February 10, 2023

**RE: Fourth RCCC Request for Formal Interpretation**

Re: **Fourth RCCC Request for Formal Interpretation (N.C. Gen. Stats. § 160D-1127)**  
Rowan Cabarrus Community College Outdoor Classroom Phase II (the "Project")  
1333 S. Jake Alexander Blvd., Salisbury, NC

**Exhibit A**  
**Location Key for Stair Runs labeling on as-built spot elevation survey all  
the runs of stairs on the project with letters A-W**  
*(Was Exhibit D to RCCC's First Request for Formal Interpretation dated December 16, 2021)*

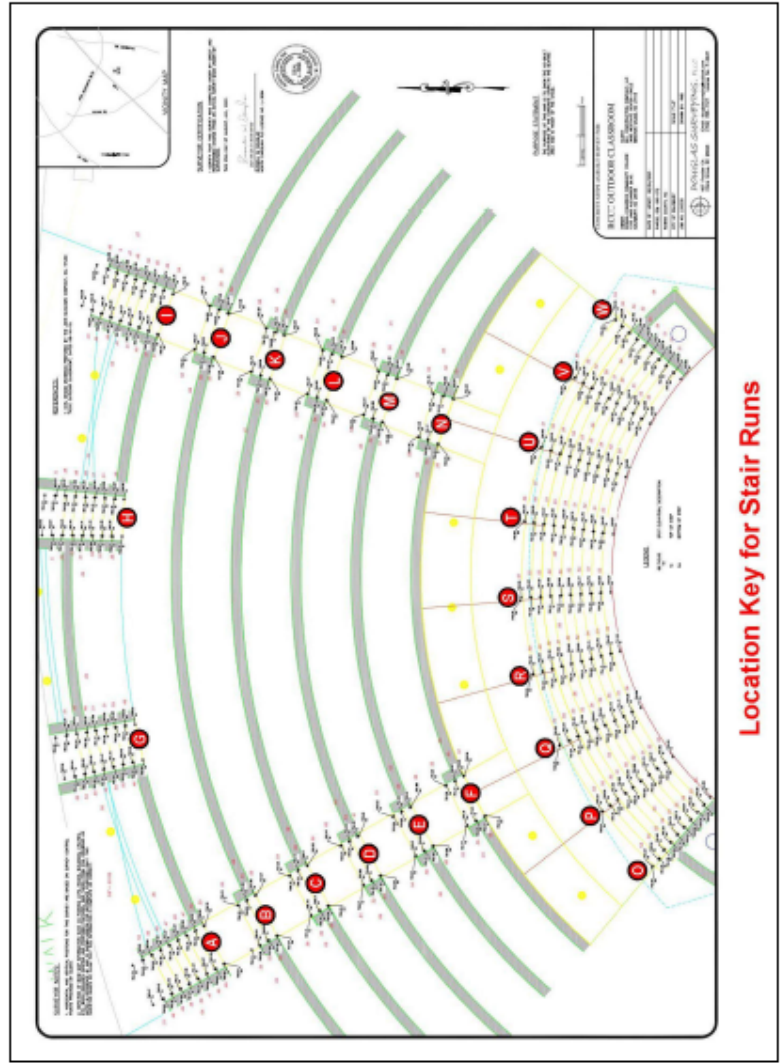
- For the Stepped Aisle (Steps B through F and J through N), the adjacent riser height uniformity tolerance is 3/16 inch (Code Section 1011.5.4);

- For the Back Exit Access Stairways (Steps A, G, H and I) and Curved Stage Steps (Steps O through W), the allowed maximum tolerance from the smallest to the greatest riser height is 3/8 inch (Code Section 1029.13.2.2.1); and
- Except for Curved Stage Steps O and P, all the as-built Back Exit Access Stairway Steps, Stepped Aisle Steps and Curved Stage Steps Q-W do not comply with Chapter 10 of the NC Building Code.

**Request One:** Is it correct that:<sup>1</sup>

- (a) pursuant to NCDOT First 01/06/22 Formal Interpretation, based on the intent of the Project Architect and the Construction Documents *as originally submitted for Permit*, the as-built Back Exit Access Stairway Steps and Stepped Aisle Steps (and Curved Stage Steps Q through W) *do not comply* with the NC Building Code;

- (b) pursuant to NCDOT Second 09/23/22 Formal Interpretation (and subsequent NCDOT Third and Fourth Formal Interpretations), *if* the Architect of Record would be willing to *revise and resubmit* signed and sealed Construction Documents for Permit with "landscape steps" and the alternative means of egress intent that has been proposed by NCDOT, *then* the as-built Back Exit Access Stairway Steps and Stepped Aisle Steps *could be considered to comply* with the NC Building Code; and

- (a) the actual intent of the Project Architect was *and without revision will continue to be* that the Stepped Aisles (Steps B through F and J through N) and back Stairway (Steps A,G,H & I) are to be used as Means of Egress?
- (b) The Project Architect's Construction Documents as submitted (*and not revised*) to the Rowan County Inspections Department for review and permitting show that the Stepped Aisles and back

Stairways were intended to be used as the primary egress from the stage and seating areas to the Public Way?<sup>4</sup>

- (c) the Project Architect neither intended *nor is interested in revising the Construction Documents to depict such intent*, for the sloped grassy areas flanking the amphitheater to be used as an Egress Court or Yard for purposes of a Means of Egress Exit Discharge?<sup>5</sup>

**Request Four:** NCDOT’s conclusions (2) and (3) set forth in NCDOT Fourth 12/01/22 Formal Interpretation essentially determined if the plans were hypothetically revised to depict the back Stairway (Steps A, G, H & I) and Stepped Aisles (Steps B through F and J through N) to be considered “landscape steps”, they would *not* be required to comply with the Chapter 10 means of egress or Chapter 11 accessibility requirements (incorporating ICC A117.1) of the 2018 NC Building Code. However, since the just-mentioned steps will still in fact be used by the public even if not a means of egress, how great a difference can the risers be with respect to adjacent risers and within a flight of steps and not run afoul with the 2018 NC Building Code?<sup>6</sup>

In response to the statement in Request 1(a), OSFM is not able to interpret the architect's subjective intent. Additionally, OSFM has never been provided with "construction documents," such as a life-and-safety plan, for the as-built Back Exit Access Stairway Steps and Stepped Aisle Steps that would clarify how these steps may have been originally designated as egress steps.

Additionally, for OSFM's interpretation of 01/06/2022, OSFM had been asked whether the as-built Back Exit Access Stairway Steps and Stepped Aisle Steps complied with the Code's tolerance requirements. For OSFM's later interpretation of 09/23/22, OSFM had been asked whether the same steps had to comply with the Code's tolerance requirements at all. Upon consideration of this different question, OSFM determined that the as-built Back Exit Access Stairway Steps and Stepped Aisle Steps did not have to comply with the Code's tolerance requirements for the reasons stated in the 09/23/22 interpretation.

That said, when and if your client completes whatever procedural steps the Rowan County Inspection Department may ask it to complete, then OSFM's interpretation of 09/23/22 will be binding on that Department, which will be required by law to conclude that the as-built Back Exit Access Stairway Steps and Stepped Aisle Steps are not required to comply with the Code's tolerance requirements. See 2018 N.C. Building Code: Admin. Code and Policies 203.2.1.2.

As explained in response to your Request 1(a) above, the OSFM was asked different questions for its 01/06/2022 interpretation than for its 09/23/22 interpretation, and OSFM answered the questions accordingly. Consequently, OSFM does not consider these two interpretations to be in conflict.

The OSFM is unaware of the term “landscape steps” appearing in the Code or any of its commentaries. The OSFM considers the term to mean steps that are not required for egress, not inside a building, constructed on grade, and used to provide a comfortable means of traversing a change in grade of an earthen landscape.

Otherwise, for the reasons expressed in the OSFM’s 09/23/22 interpretation, the steps at issue in this Request 4 are not subject to the Code. Consequently, there is no limitation on any difference between the risers with respect to adjacent risers and within a flight of steps.
